Application Number: 2014-149 **Application Date:** 08/11/2014
CBL: 057 C023001 **Application Type:** Level III Site Plan Under 50,000 sq f
Applicant: MAY STREET 7-9 LLC /Alex Waters
Project Name: 3 Unit townhouse
Address: 7 MAY ST
Project Description: New Construction of a 3 unit townhouse located at 7 - 9 May Street in the West End
Zoning: B1/R6

**7-9 MAY STREET
PORTLAND, MAINE**

**Application For:
Final Site Plan Level III Review**

RESPONSE TO STAFF COMMENTS

Project:	151.06001
Sheet No:	C1

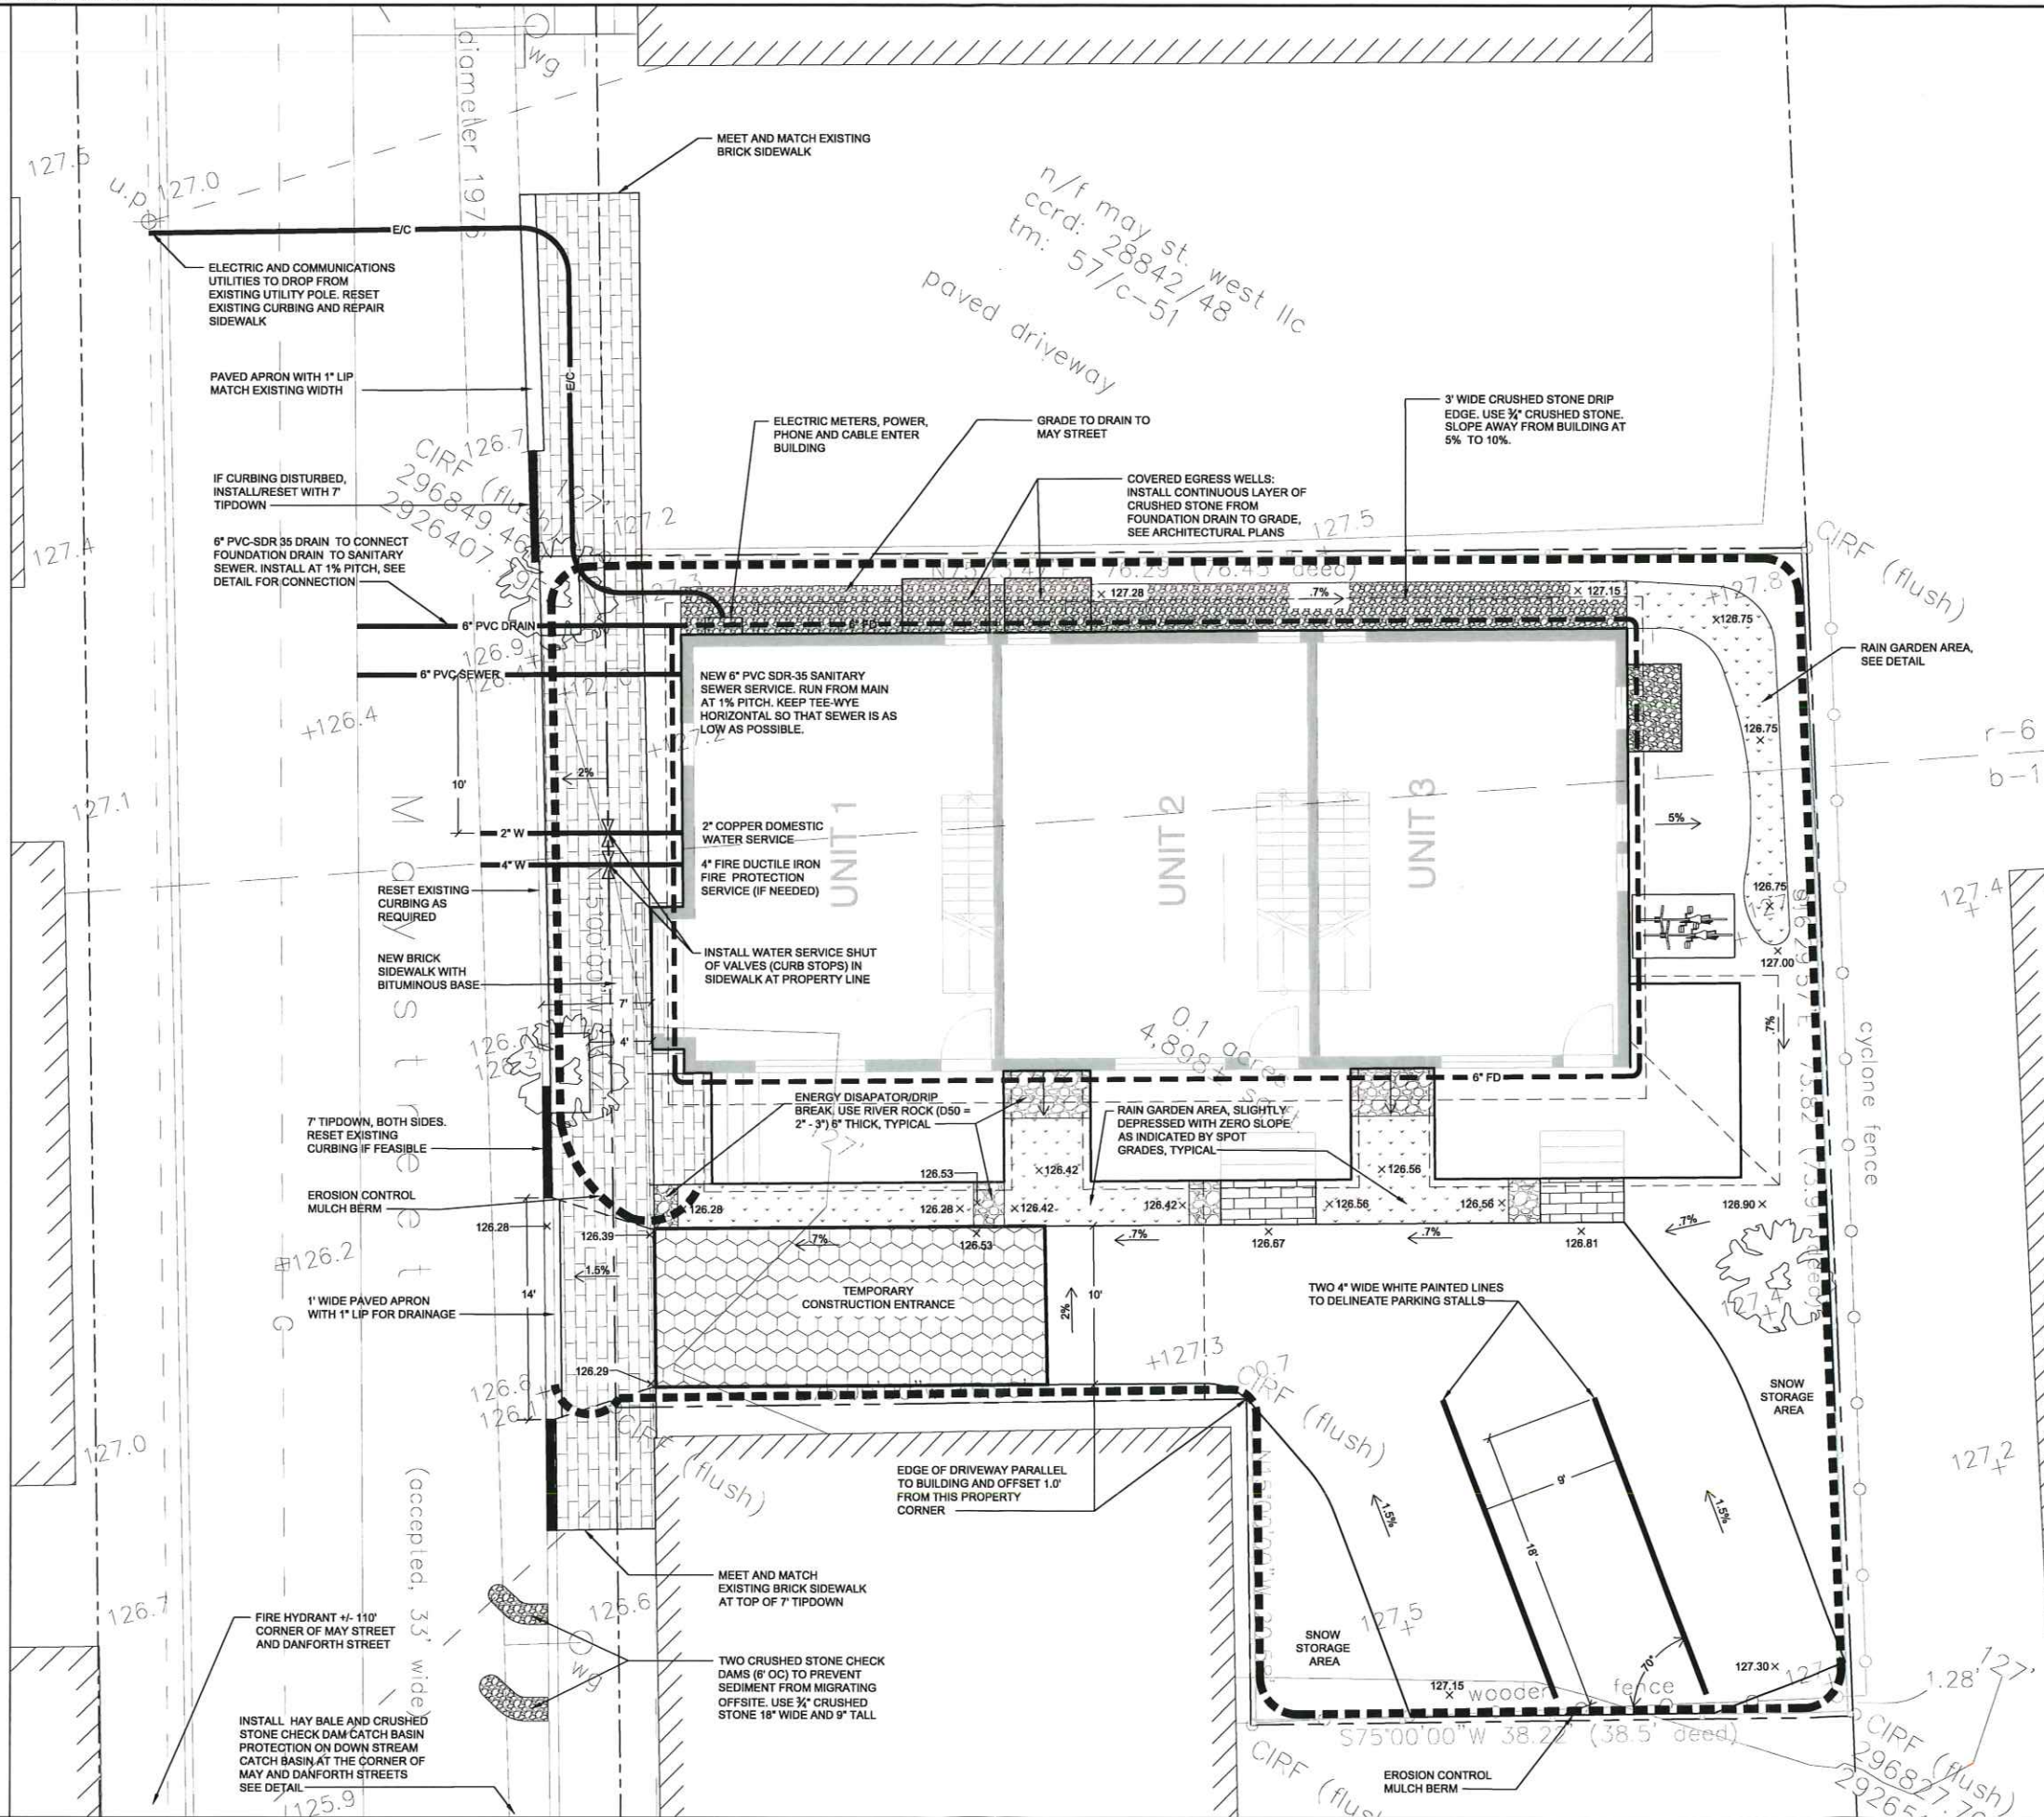
10. All plans will need to be stamped by a professional
11. Show all existing and proposed utility connections
Response: Proposed utility connections and existing utilities are shown on Sheet C1.

4. More detail is needed on utilities to site which are required to be underground from the street right of way.
Response: All utilities are proposed to be underground. Additional detail is provided on sheets C1 and C2.

6. Please add note that all work within the road right of way shall meet City of Portland Technical Manual standards.
Response: A note has been added to sheet C1.

Response: Driveway construction details are shown on Sheet C2
9. Please show a grading plan for the site.
Response: Proposed grading is shown on Sheet C1.

Response: Based on the City's technical manual (1.7.1. Residential development with nine (9) parking spaces or less) the minimum driveway width is 10'. We are proposing a 10' wide driveway with a 2' flair on each side, which results on a 14' wide (end of tipdown to end of tipdown) curb cut as shown on Sheet C1.

1. The project proposes a 12-foot driveway that meets City standards.
Response: Based on the City's technical manual (1.7.1. Residential development with nine (9) parking spaces or less) the minimum driveway width is 10 feet. We are proposing a 10 foot wide driveway with a 2-foot flair on each side resulting in a 14' wide curb cut (end of tipdown to end of tipdown) as shown on Sheet C1.

Response: The parking layout has been revised such that the head-in parking is now 70 deg. angled parking. Three 9' wide by 18' long spaces are provided as shown on Sheet C1. Ransom conducted a turning template analysis using the passenger design vehicle template shown below. Vehicles will pull into the stalls forward and then back out onto May Street. The adjustment to angled parking results in a substantial improvement in operations over the previously shown head-in parking. It is our opinion that parking operations at this site will be typical of parking operations at other multi unit-sites in the West End.
